Author response to Anonymous Reviewer #1

Author response to Anonymous Reviewer #2

Author response to D. J. Diner

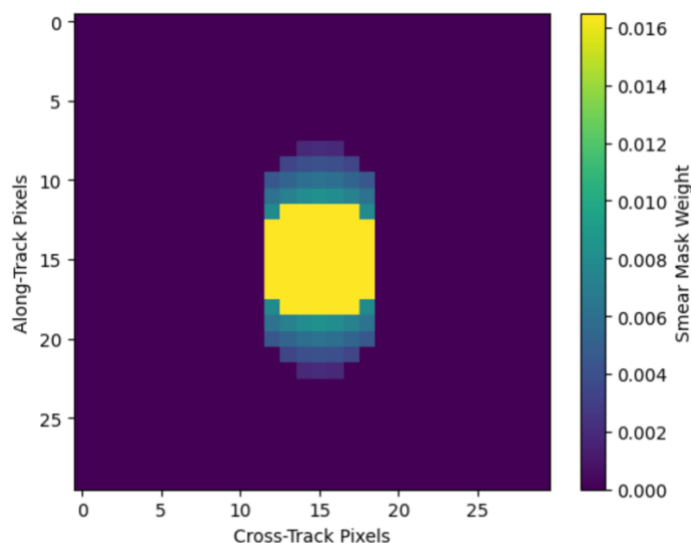
Page 25, line 610: is the RSP footprint a circle, or an oval? There is the IFOV, but an integration time that makes it like an oval. The Knobelspiesse 2019 paper you cite has a model for this as well as McCorkel et al 2016. It would potentially make your fits slightly better.

The revised intercomparison technique uses a smear oval like Knobelspiesse et al. (2019). We felt it important to preserve the native footprint of the RSP from ER-2 altitude (220m) relative to AirHARP (7x7 circle, each pixel is 20 m ground res. in L1B) and then linearly decrease the weighting of the pixels in the heading direction (forward and aft). The smear is 110m in both directions from the edge of the main core. The following is an example of the smear oval mask used in the intercomparison:
